UPC Renewables Australia Pty Ltd
ACN 616 856 672
ABN 27 616 856 672
Suite 2, Level 2, 13 – 17 Castray Esplanade
Battery Point, TAS, 7004

21 June 2021

SSD-10452 Stubbo Solar Farm Response to RFI

Figure 1 – Indicative layout of a DC-coupled BESS and solar PCU within a PV array

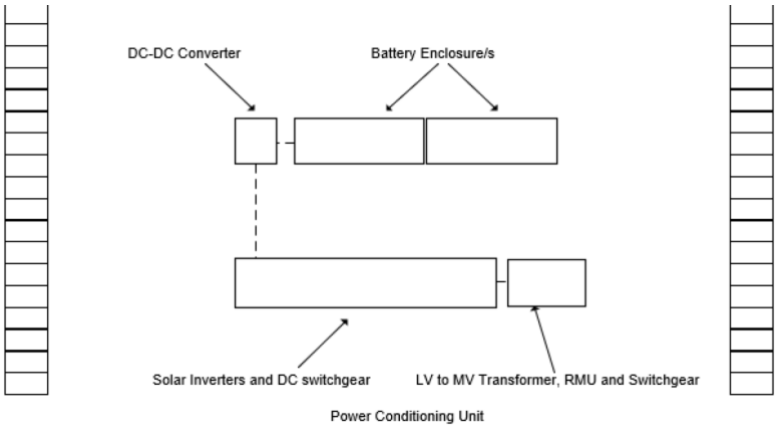
- **Centralised BESS and DC-coupled BESS**

The EIS assesses two options for either a centralised BESS (at either location A or B) or a DC-coupled BESS unit to be installed adjacent to solar inverters throughout the proposed development footprint. The revised Project layout figure attached to this letter provides clarification on these mutually exclusive options.

The diagram below shows an indicative layout of a DC-coupled BESS and solar Power Conditioning Unit (PCU) within a PV array, within the development footprint.

Figure 1-1 | Project layout

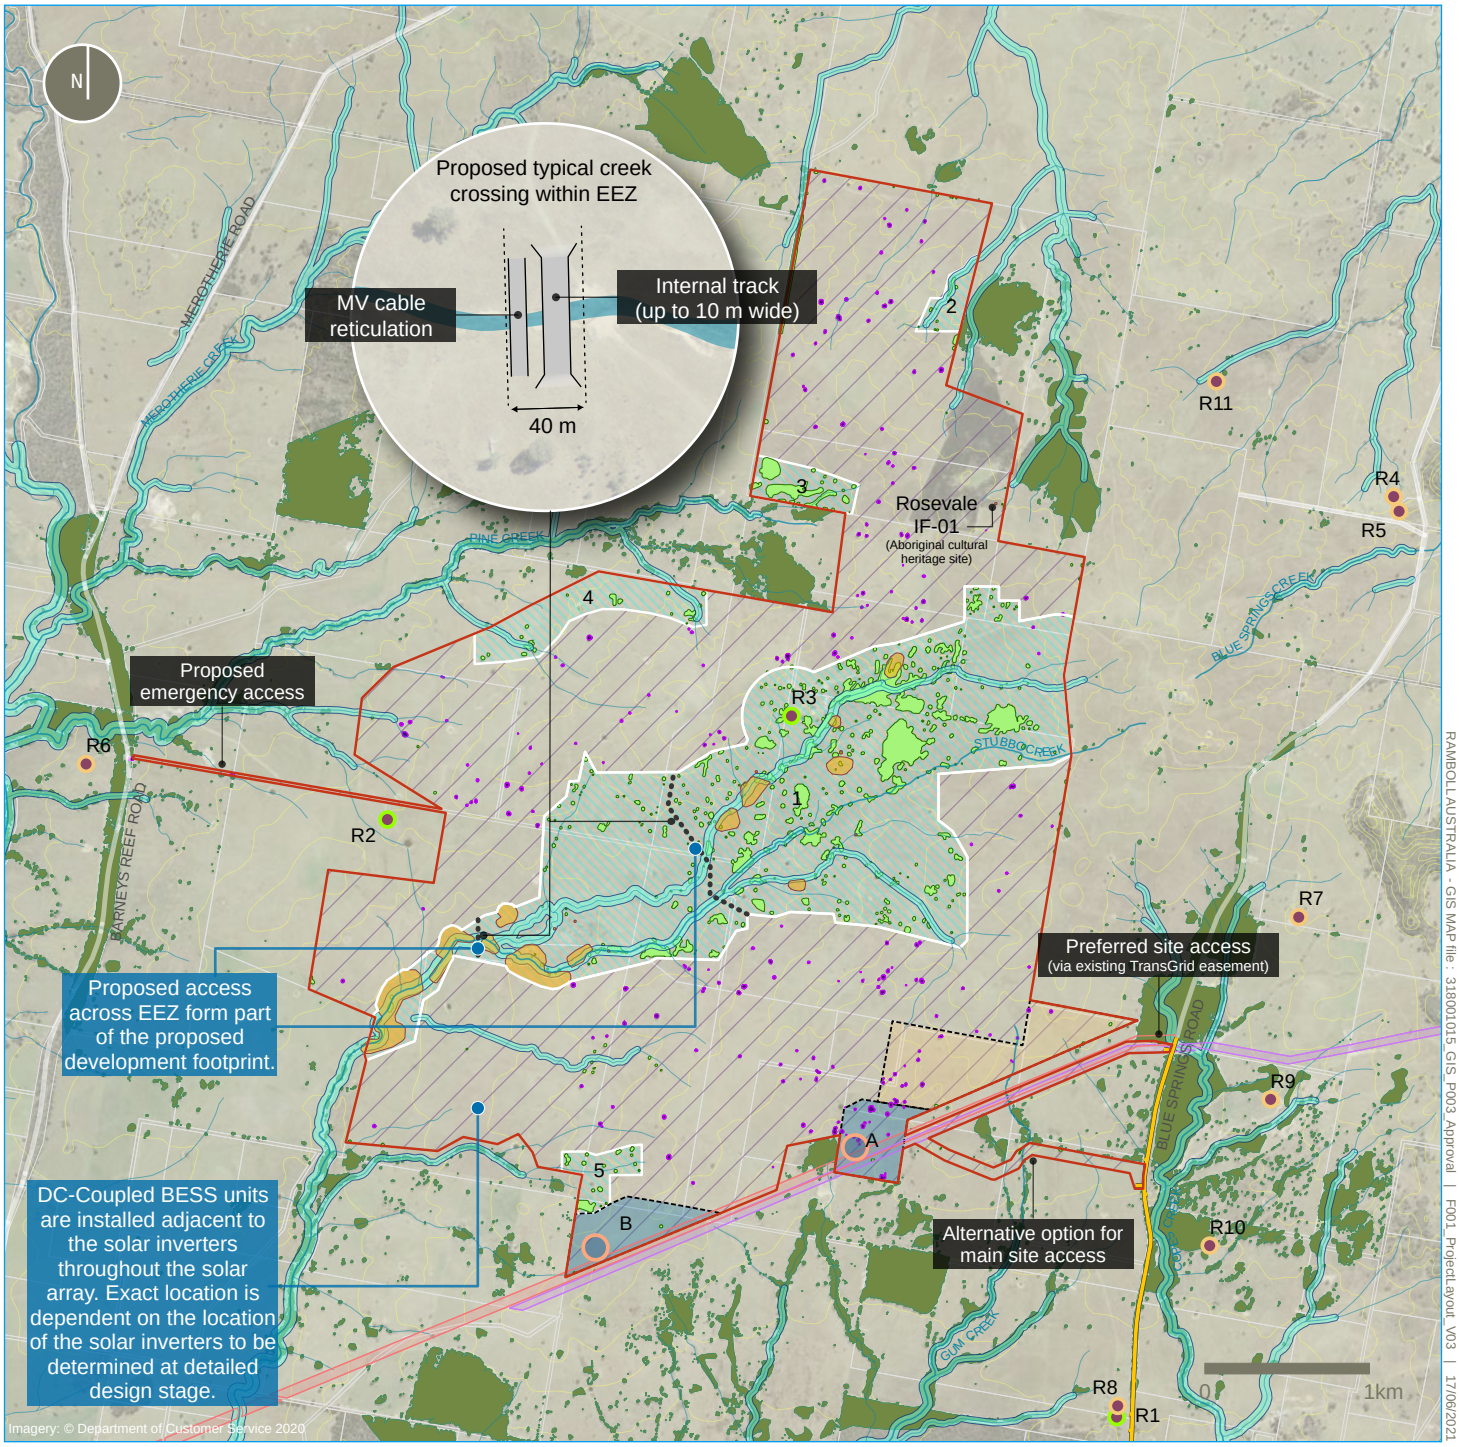
- **Distances to sensitive receivers**

- **Discrepancy between sensitive receivers labels in the Amendment report and LVIA**

For clarification purposes, UPC\AC confirms the following distances from the project boundary (revised to exclude proposed access tracks and proposed Blue Springs Road upgrade):

Please refer to the revised Project Layout attached to this letter for the location of sensitive receivers.

The Land Visual Impact Assessment report included in the EIS labelled known sensitive receivers within 5km of the project boundary. In the LVIA, 'R11' referred a sensitive receiver located more than 2kms to the north west of the proposed boundary. The updated Project Layout figure in the Amendment report only shows sensitive receivers located within 2km of the project boundary and therefore does not include the abovementioned sensitive receiver.

After Public Exhibition, the Amendment report assessed environmental impacts, including visual impacts on a sensitive receiver that was not initially identified in the EIS. This newly identified sensitive receiver was labelled 'R11' in the Amendment report in order to be consistent with the

numbering shown on the Project Layout figure. All references to sensitive receiver 'R11' in the Amendment report and the Response to Submission report apply to the additional sensitive receiver located to the northeast of the project boundary only.

Figure XX-X | Construction traffic routes assessed

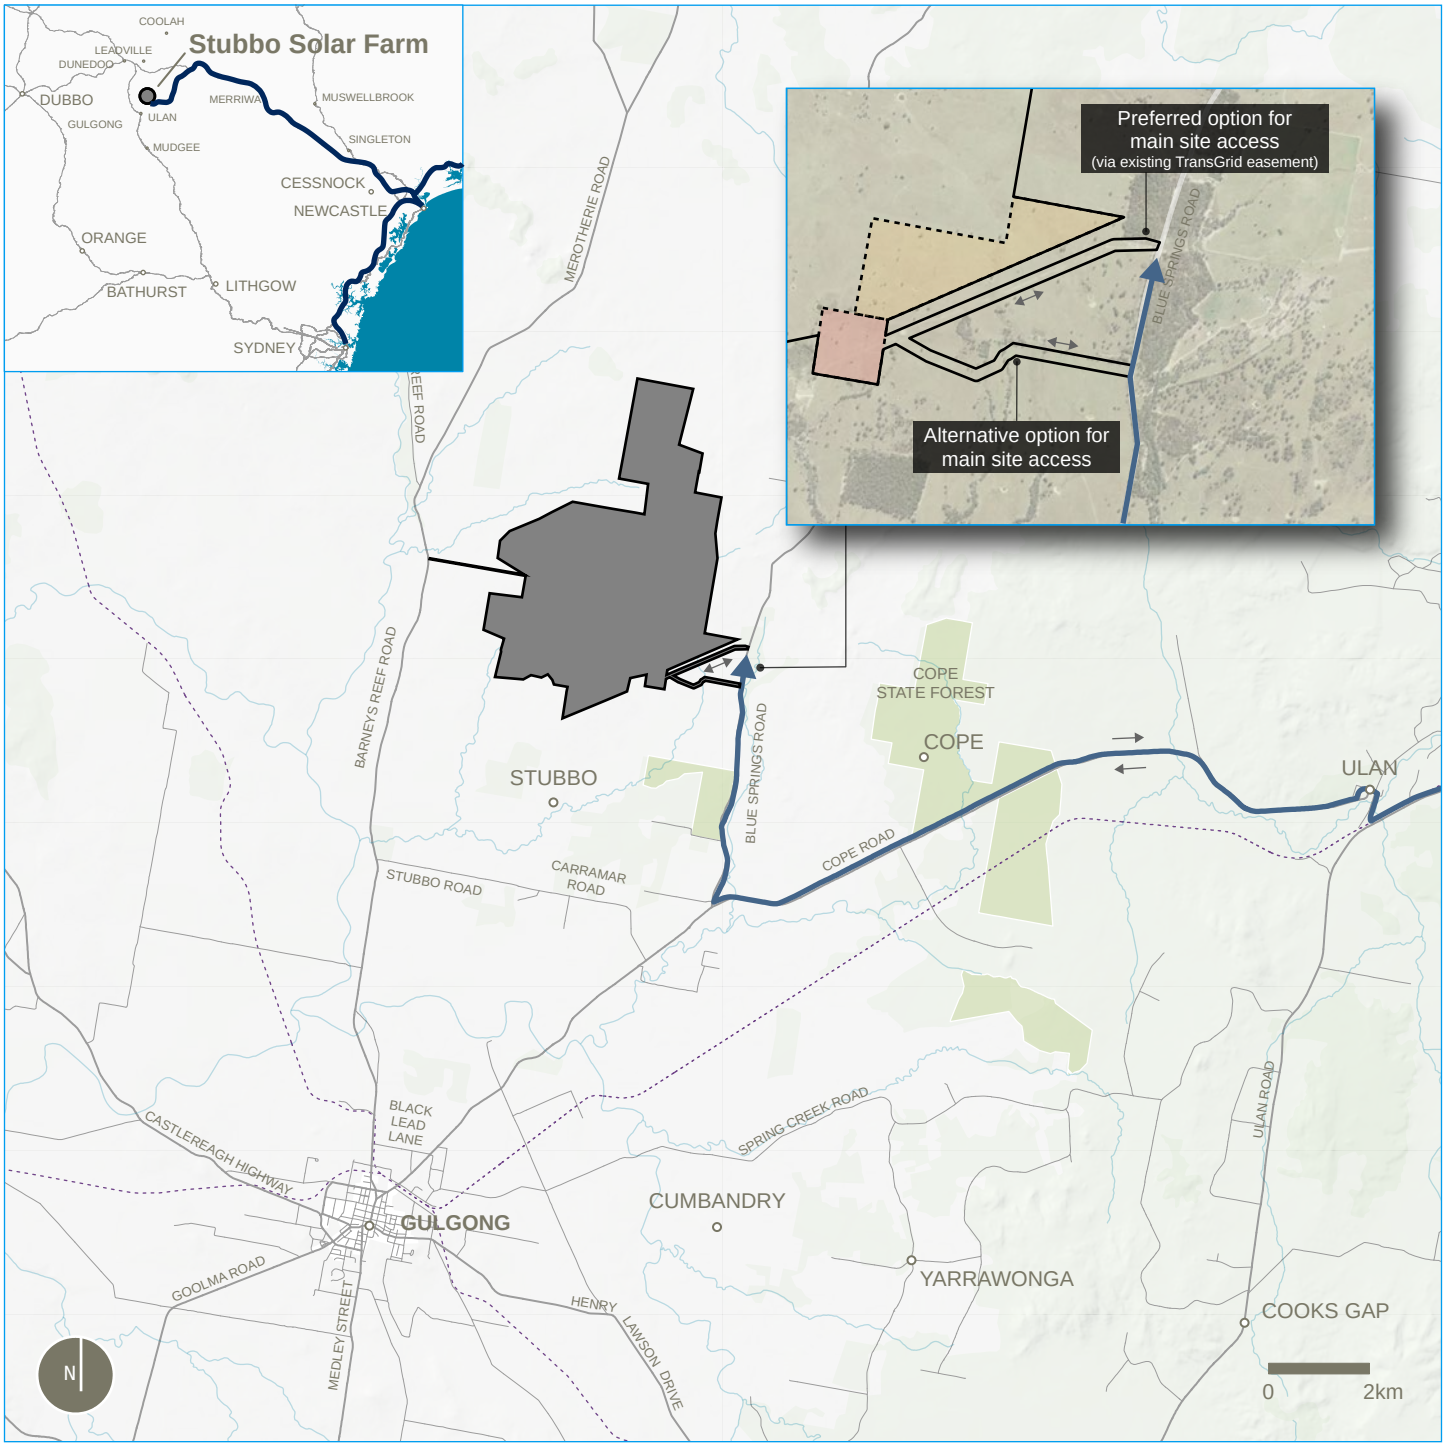
- **Clarification on the proposed access route to the site**

The proposed access route assessed in the EIS includes access via the Golden Highway, Ulan Road, Cope Road (state roads) and then Blue Springs Road (Council road). A revised map showing the proposed access route is attached to this letter. This is the only access route proposed.

Figure 2-3 | Indicative layout of subdivision area for switchyard

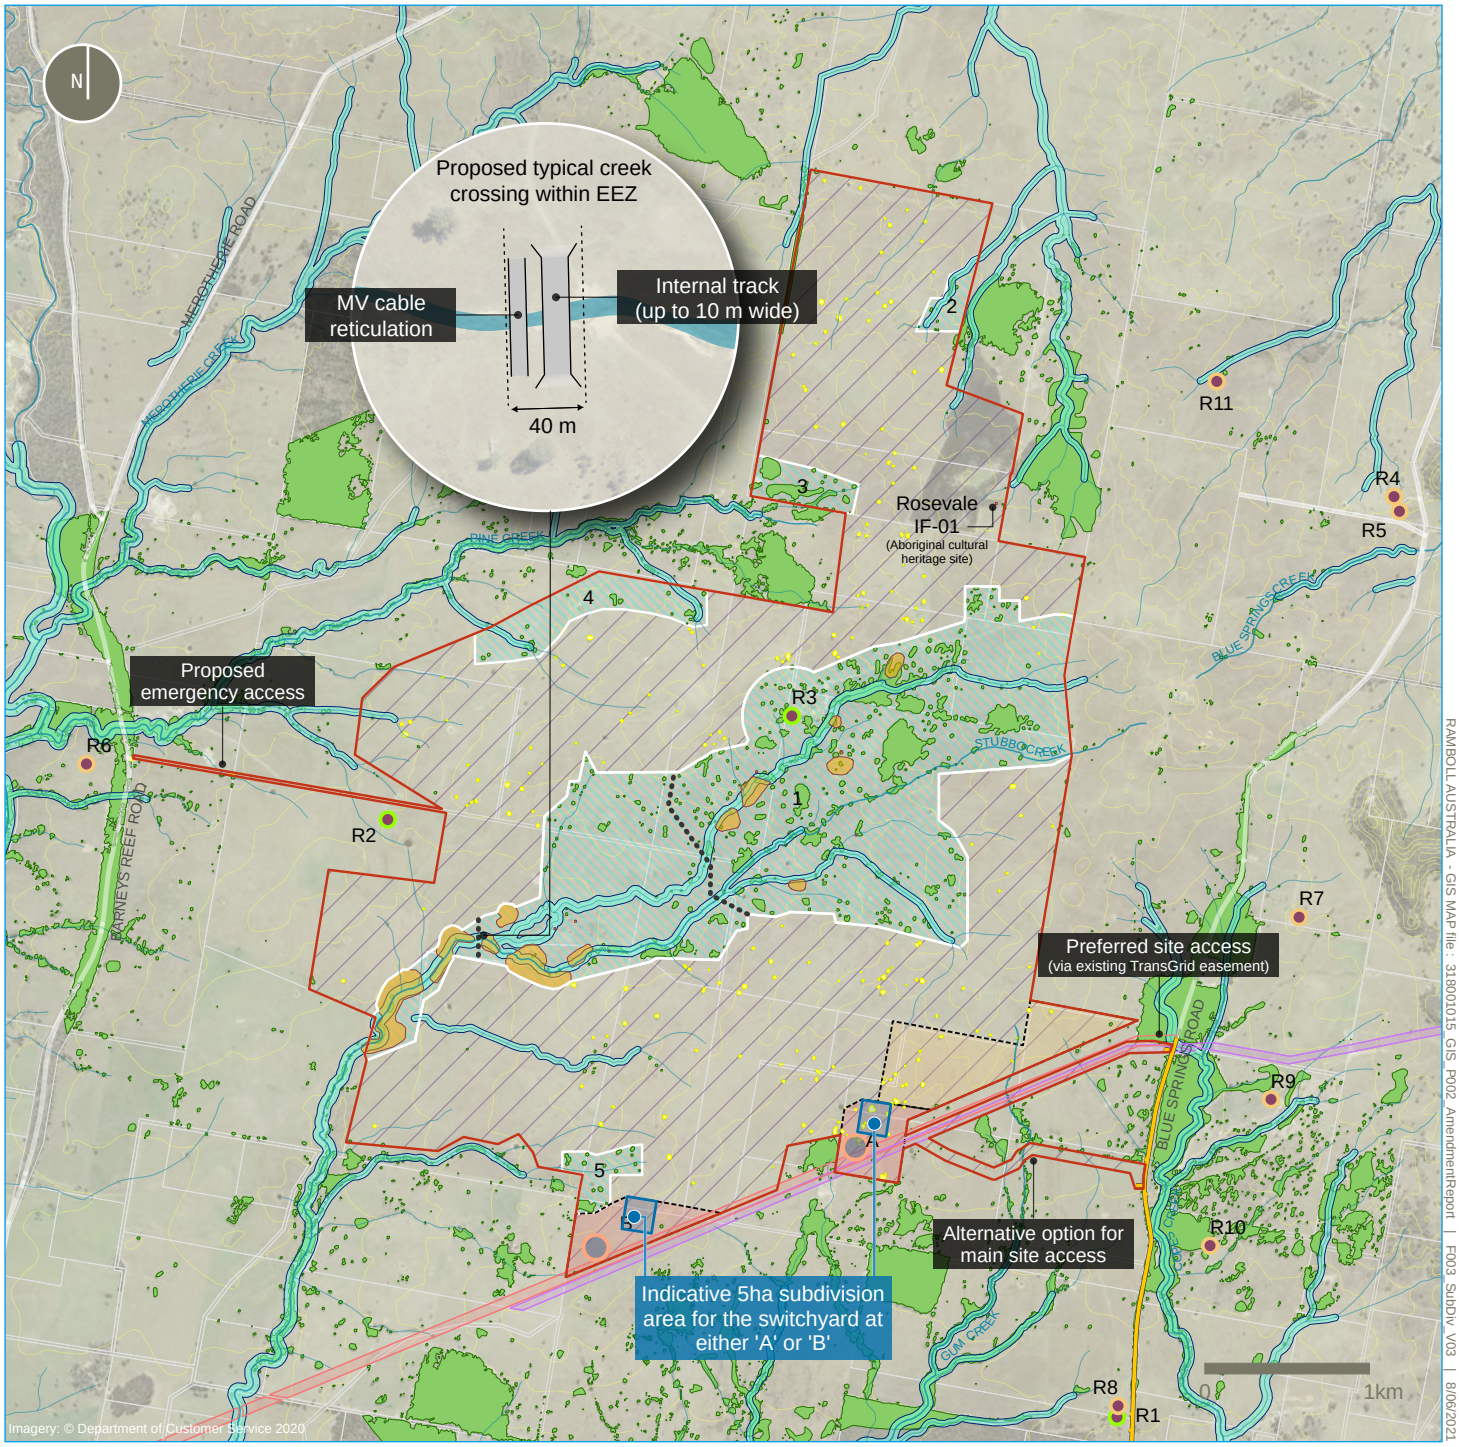
- **Clarification on the proposed subdivision**

A detailed figure of the proposed subdivision is attached to this letter. Subdivision of the switchyard which is likely to be required by TransGrid is proposed at either Option A or B (substation location options). The figure also shows cadastral lots potentially affected by the subdivision. The area of subdivision will not exceed 5 hectares as outlined in the Amendment report.
